# Conceptual Review Agenda

# CSU Parking Garage

**Re:** CSU Parking Garage

**Description of project:** This is a request to build a parking garage on the CSU campus (Parcel #9714413904). The garage will replace an existing portion of a surface parking lot and result in a net gain of 466 parking spots. The proposed garage will be four stories. The parcel is located in the Community Commercial (CC) zone district. This proposal will be subject to Site Plan Advisory Review (SPAR).

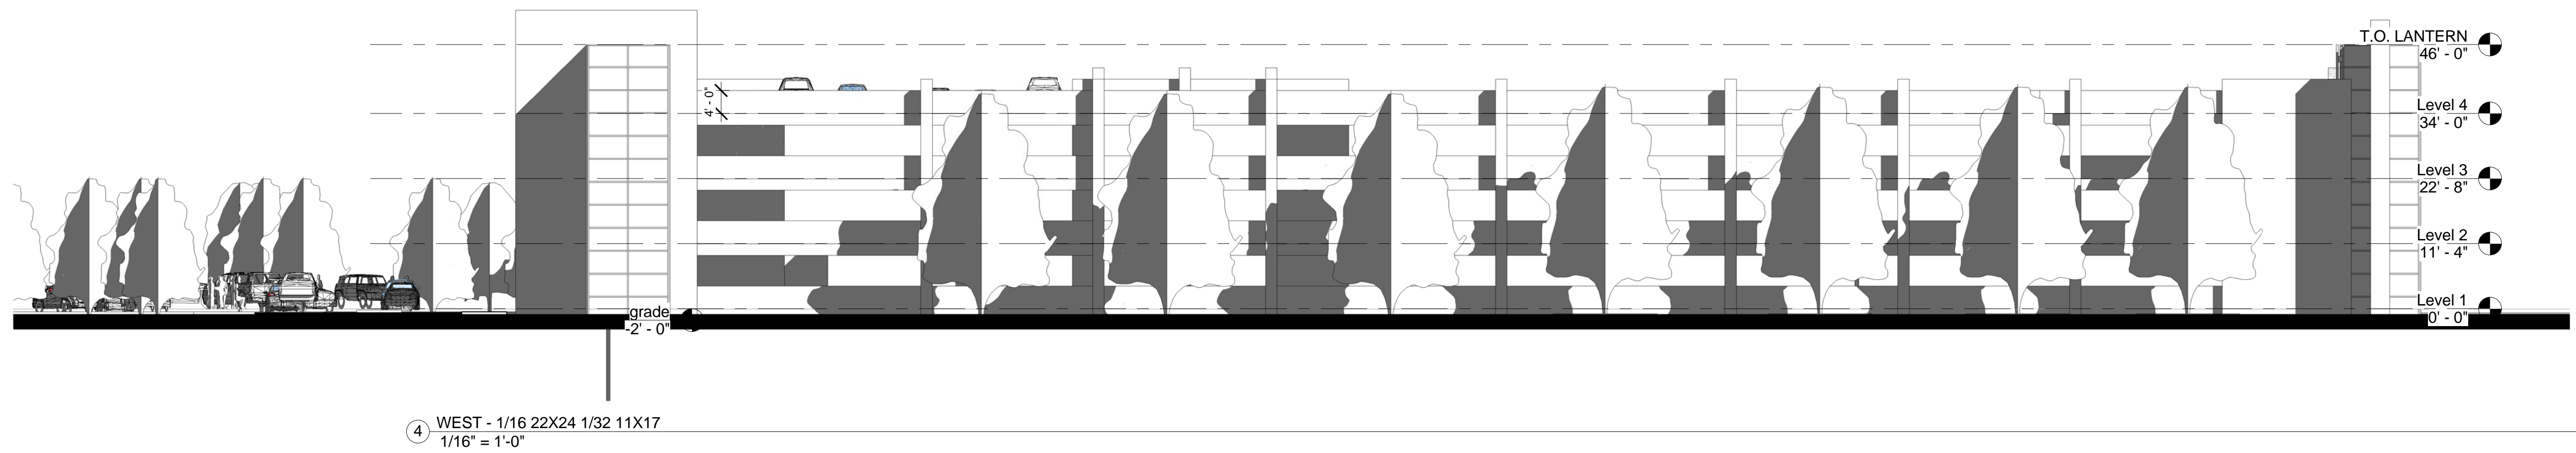
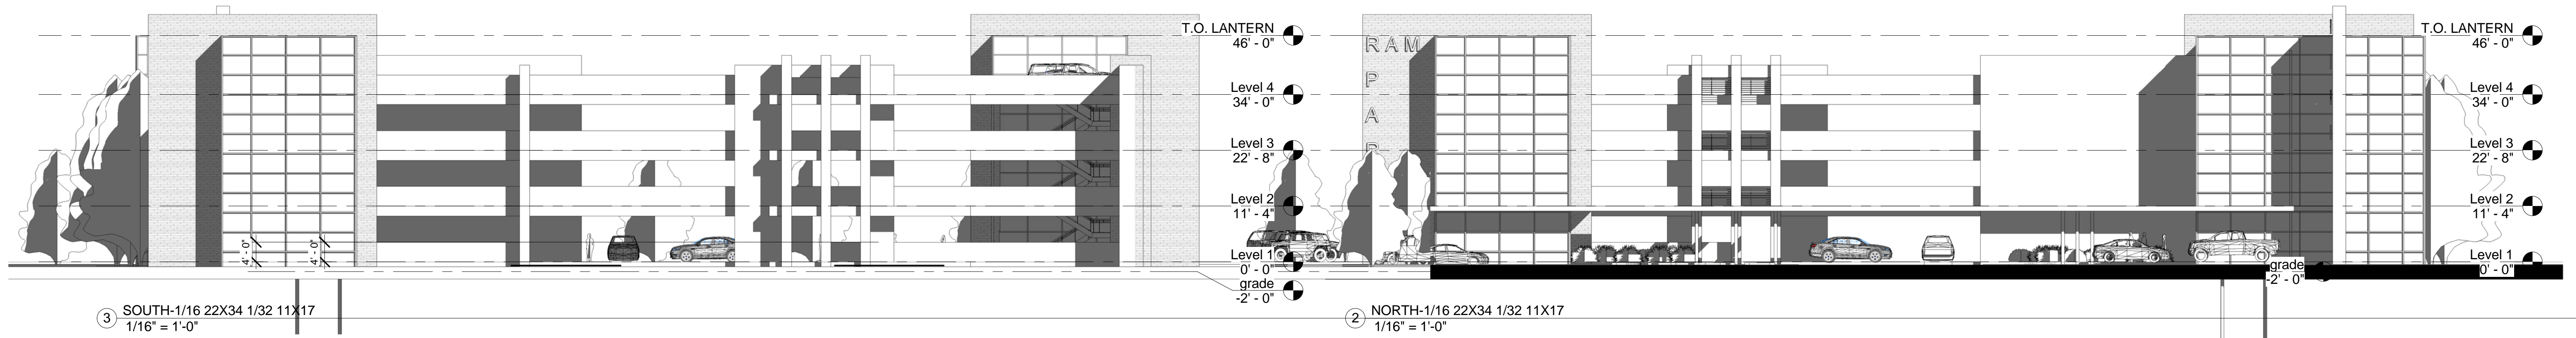
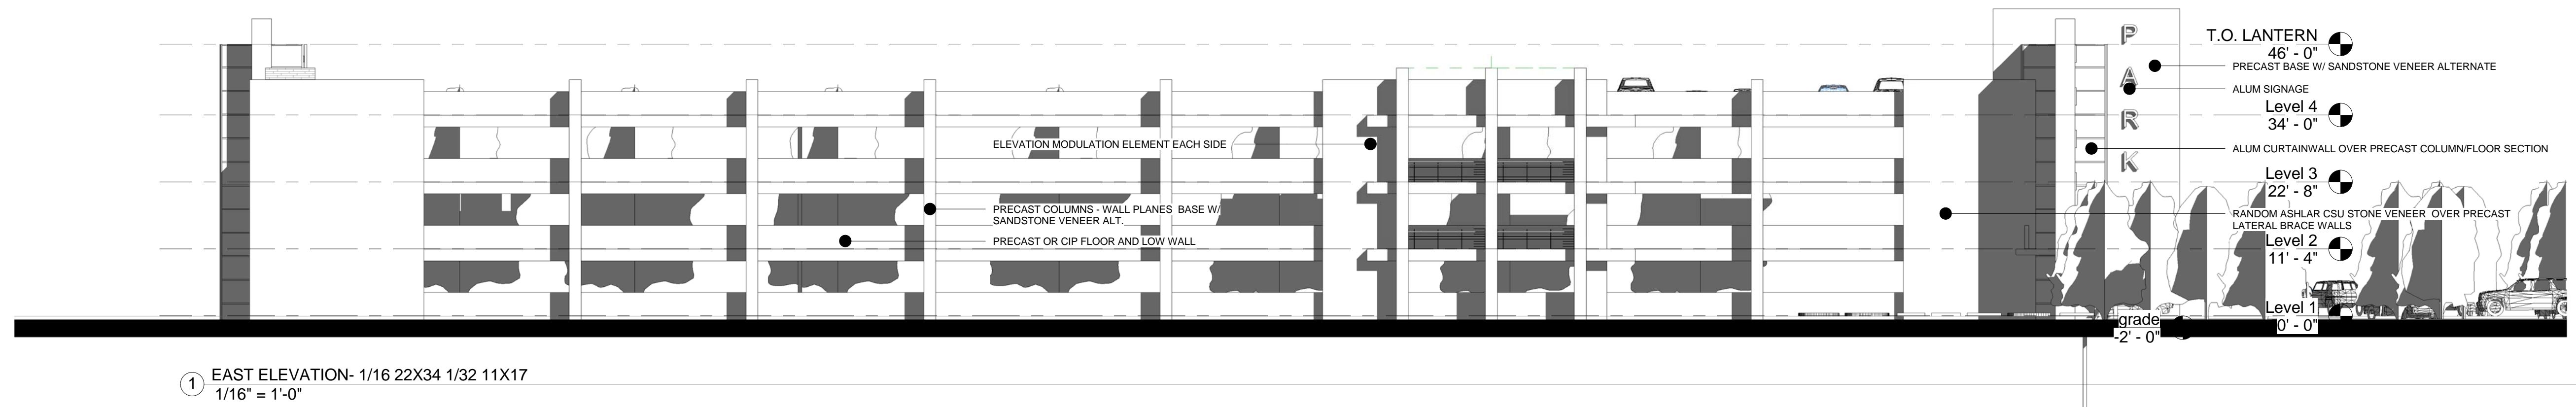
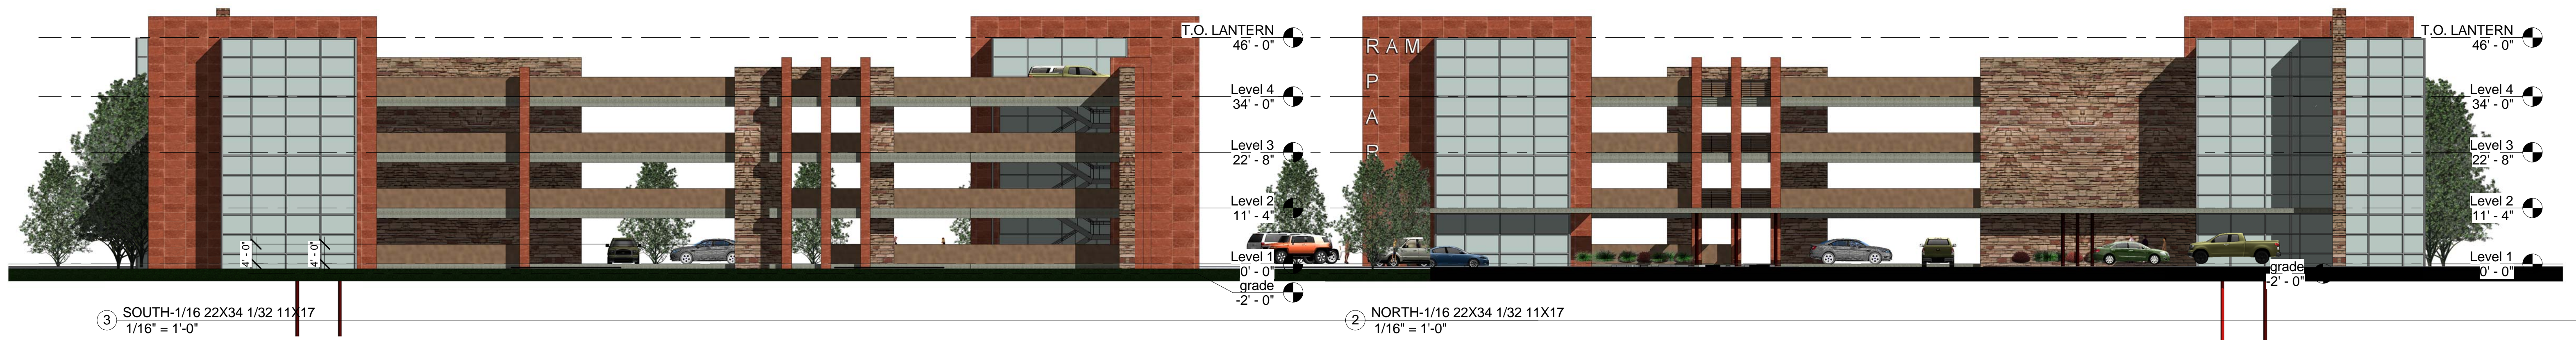
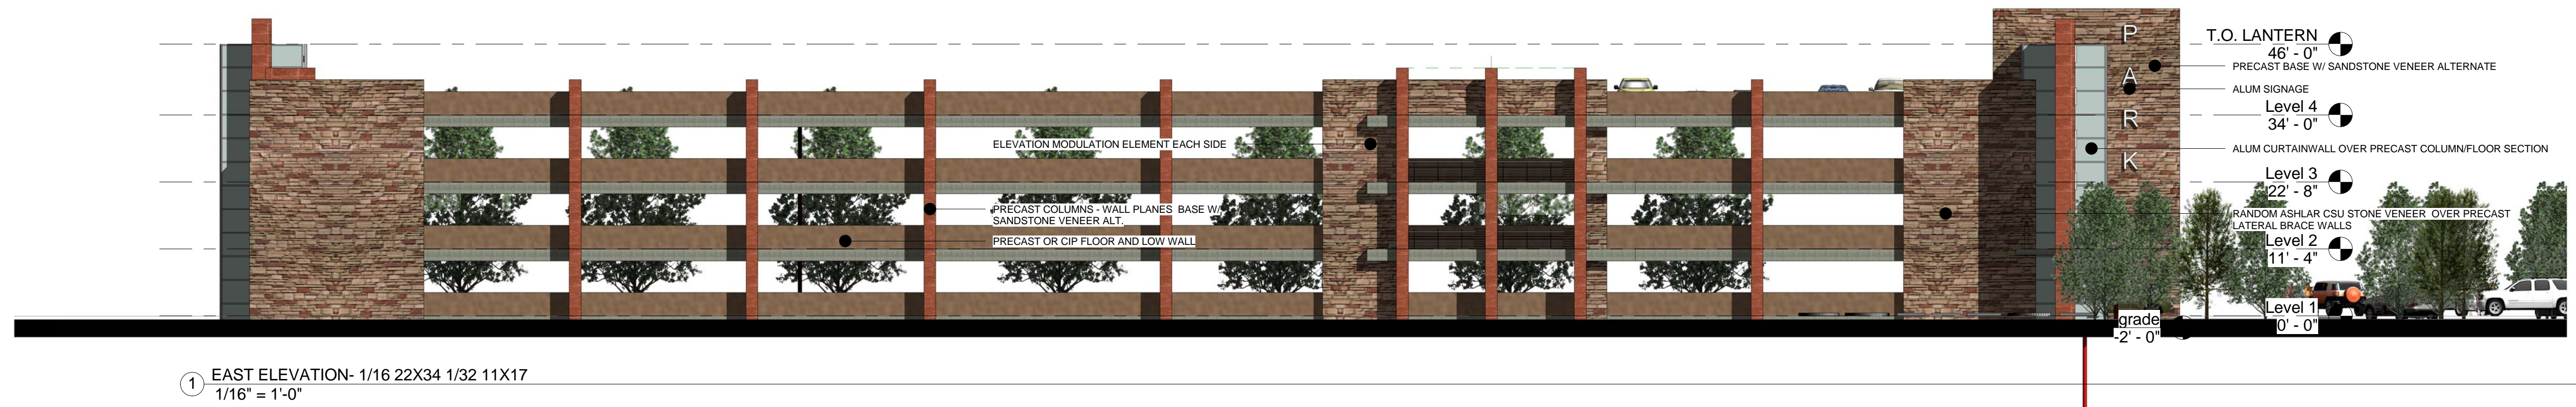
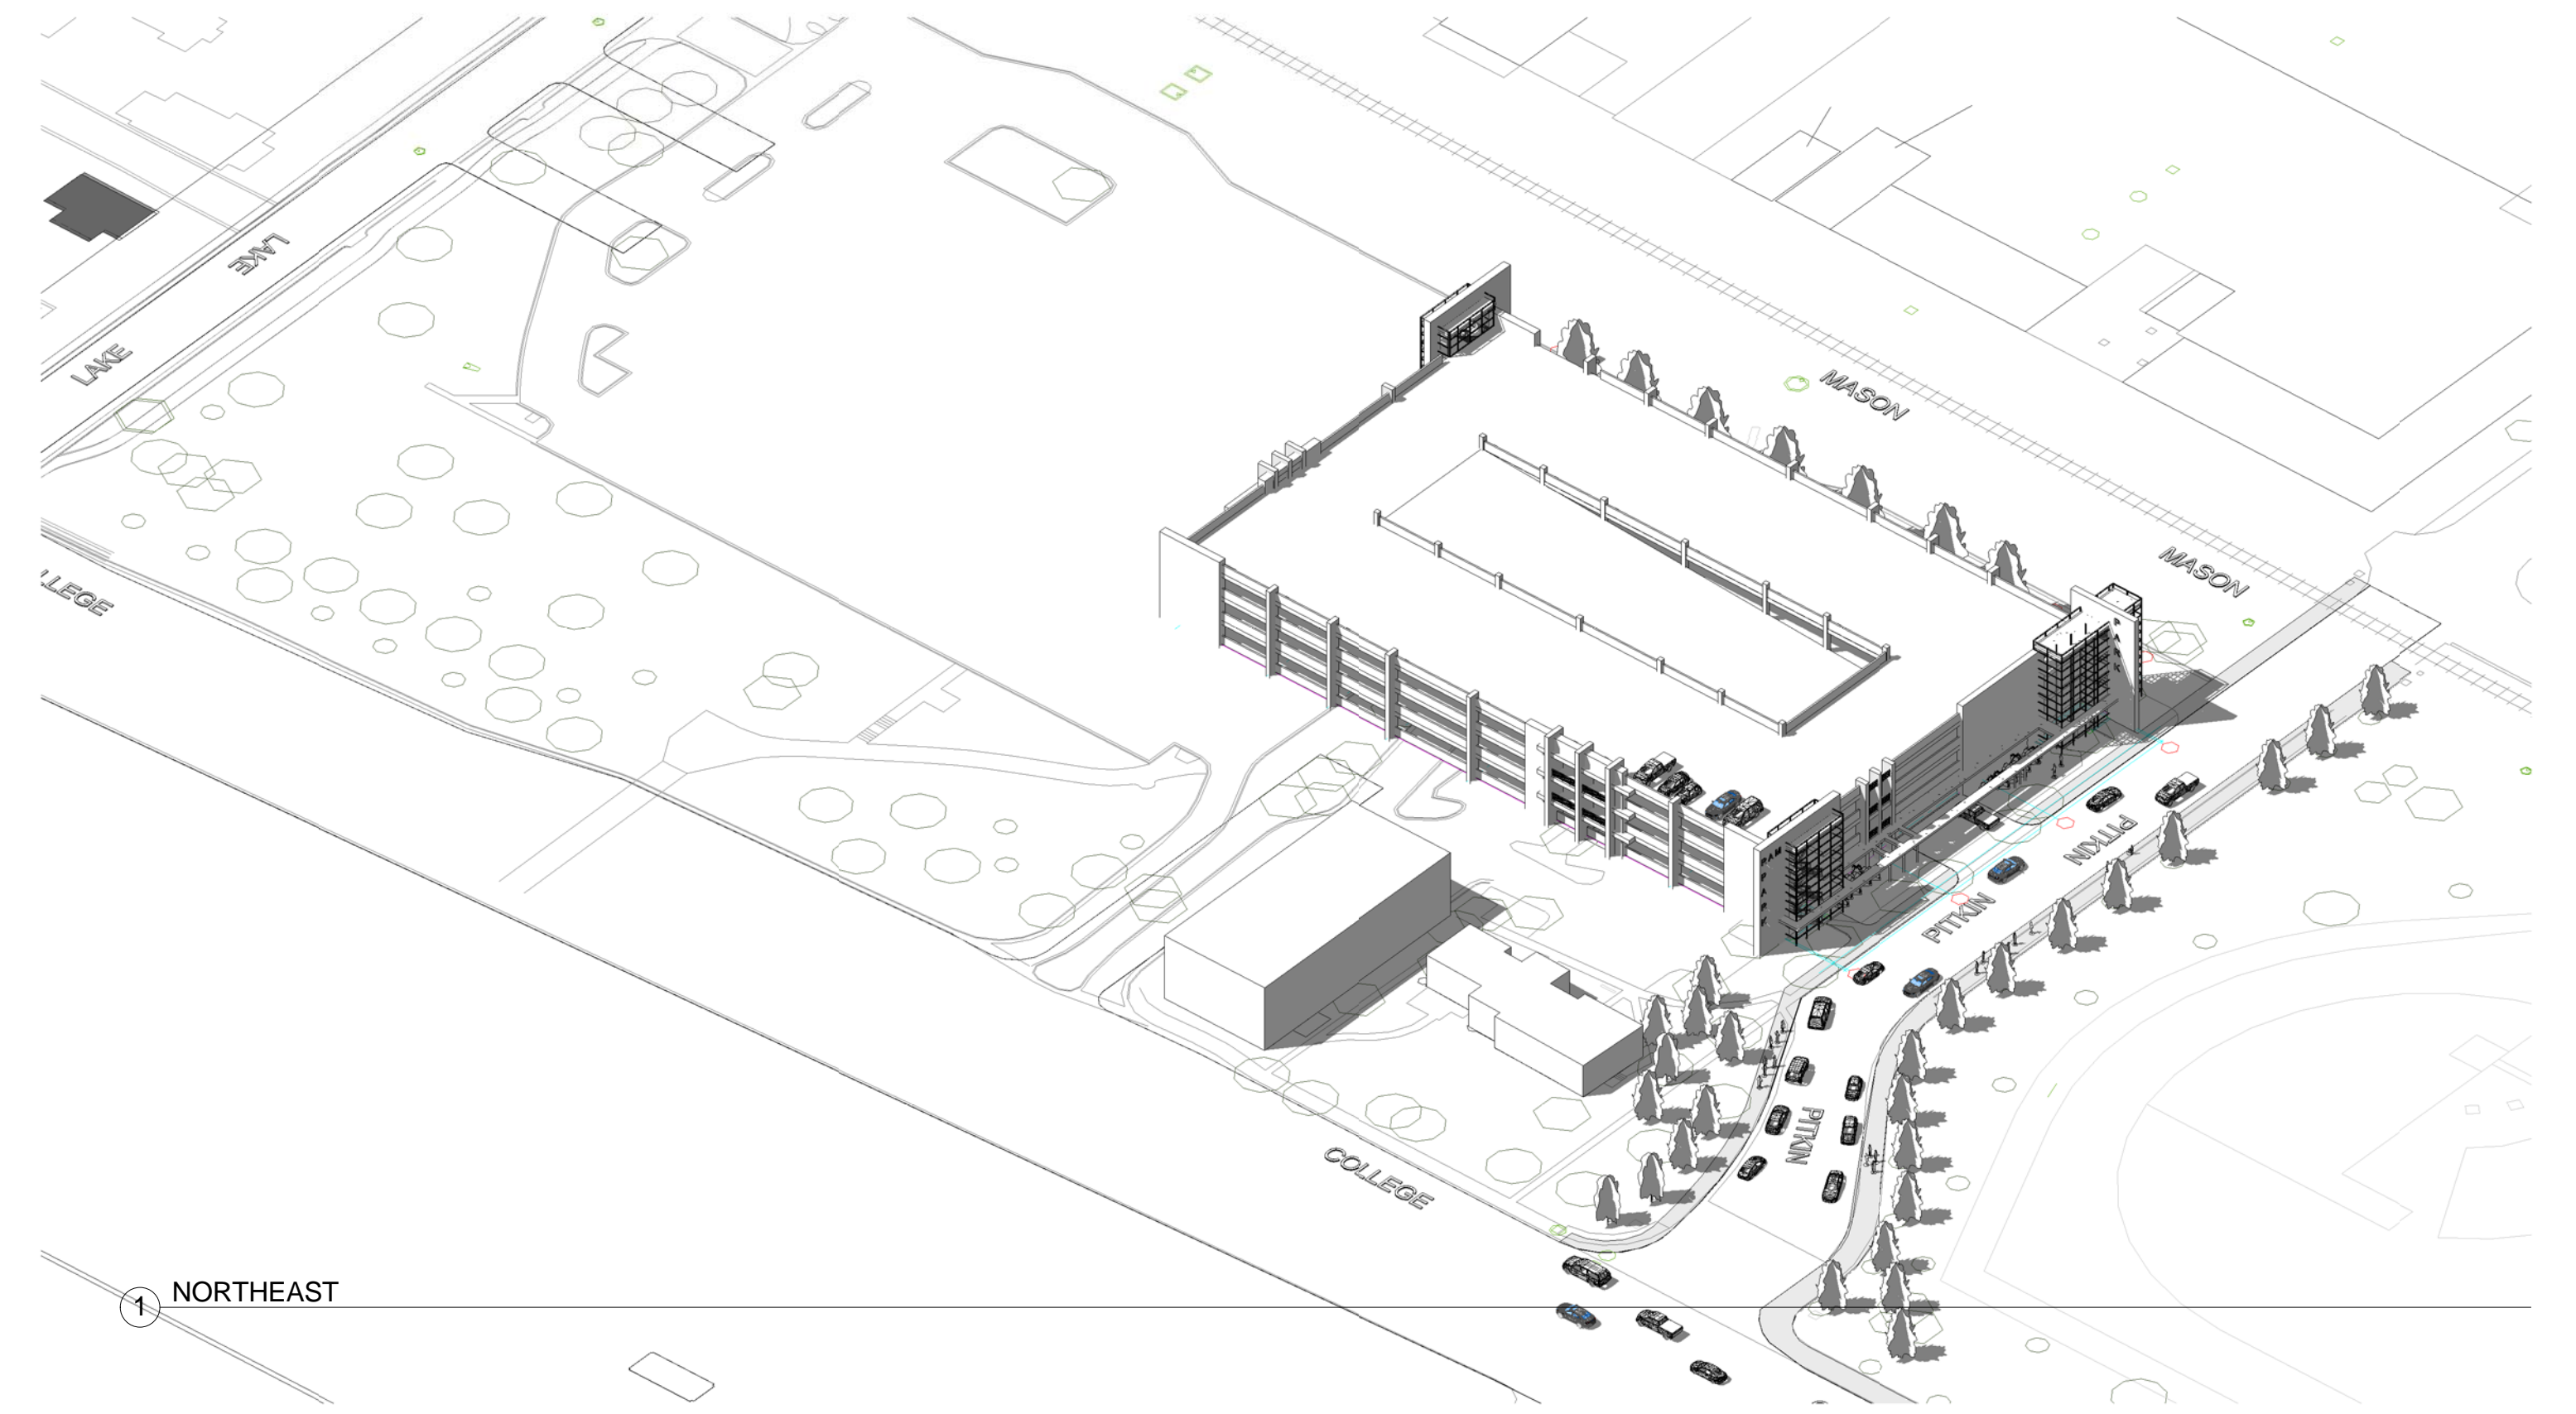
1. Regarding signage City code required a vertical sign or message be no taller than 7' in height. It appears that proposed signage shows the vertical message "PARK" to be taller than 7'.
2. No other comment.

1. It might help to clarify on the elevations the character of the glazing material enclosing the stair towers. How much opacity/reflectivity? Example photographs of materials for P&Z might be helpful.

2. Are lighting fixtures proposed on the parking structure? It would help to show the locations for new exterior lighting fixtures and clarify full cutoff/down directional lighting will be provided.
